## **LIGHTHOUSE BAPTIST CHURCH SUBDIVISION**

APPLICATION NUMBER 8 DATE July 8, 2010

REQUEST Subdivision

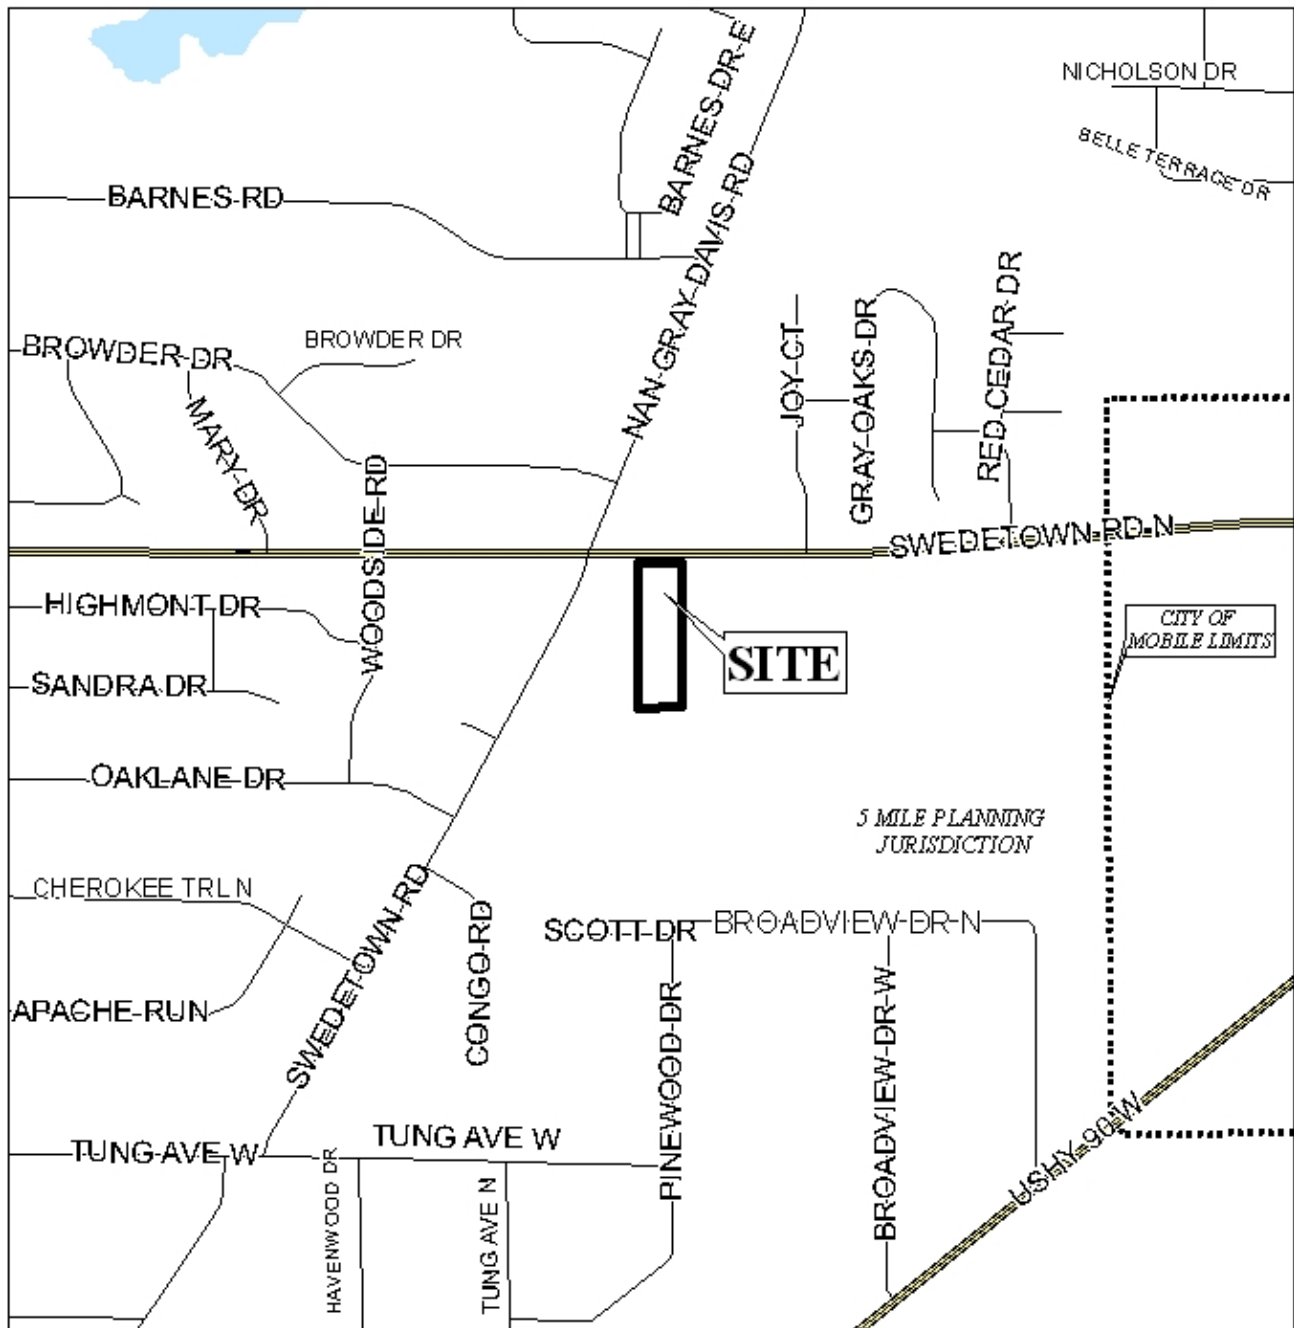
The proposed lot meets the minimum size and frontage requirements as regulated by Section V.D.2. of the Subdivision Regulations. The 25-foot minimum building setback line is not depicted on the preliminary plat, and this should be shown on the Final Plat. Further, the lot area size is not depicted, as such, the proposed lot should be labeled with the lot area size, in square feet, or a table be provided on the Final Plat with the same information.

The proposed lot faces Swedetown Road North, a major street as shown on the Major Street Plan component of the Comprehensive Plan. Adequate right-of-way was dedicated when the Hatcher-Smith Subdivision was approved by the Planning Commission as stated earlier. As such, no further dedication should be required. It should be noted that this dedication is being depicted on the Preliminary Plat. As this dedication has already occurred, this dedication notation should be deleted.

As Swedetown Road North is a planned major street, access management is a concern. The Hatcher-Smith Subdivision limited the three existing lots to two total curb cuts, and, as such, the new lot should be limited to two curb cuts, with the size, design, and exact location of all curb cuts to be approved by County Engineering and conform to AASHTO standards.

- 1) depiction of the 25-foot minimum building setback line along all right-of-way frontages on the Final Plat;
- 2) labeling of the lot area size, in square feet, or provision of a table on the Final Plat with the same information;

- 3) placement of a note on the final plat limiting the site to two curb cuts to Swedetown Road North, with the size, design, and location of all curb cuts to be approved by Mobile County Engineering and conform to AASHTO standards;

- 4) deletion of dedication information;
- 5) Placement of a note on the final plat stating that the development will be designed to comply with the storm water detention and drainage facility requirements of the City of Mobile storm water and flood control ordinances, and requiring submission of certification from a licensed engineer certifying that the design complies with the storm water detention and drainage facility requirements of the City of Mobile storm water and flood control ordinances prior to the issuance of any permits. Certification is to be submitted to the Planning Section of Urban Development and County Engineering;
